Access Compliance Report

Public Rights-of-Way

(Pedestrian Signals)

Intersection ID: N/A	Main Street:	Cross Street: N/A	Location: N/A
ADA ID: D6A96D77CD1B	Signal Type: One Push Button-APS	Overall Compliance: No	Severity Score: BTN 1: N/A BTN 2: N/A No BTN: N/A
Codes/Mitigation Info/Possible Solution		Field Measurements/Component Compliance

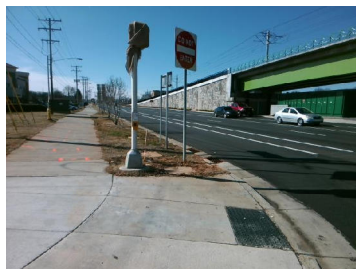
Surveyor Notes: NOT HOOKED UP, NOISES
AND VERBAL COMMANDS UNKNOWN

PROW/ADA: R404.2, R404.3, R404.7.2,
R104.2, R209.1, MUTCD 4e.08,

Possible Solutions: Remove & Replace
Replace APS Button With New APS Button.
Remove and Replace Clear Space.
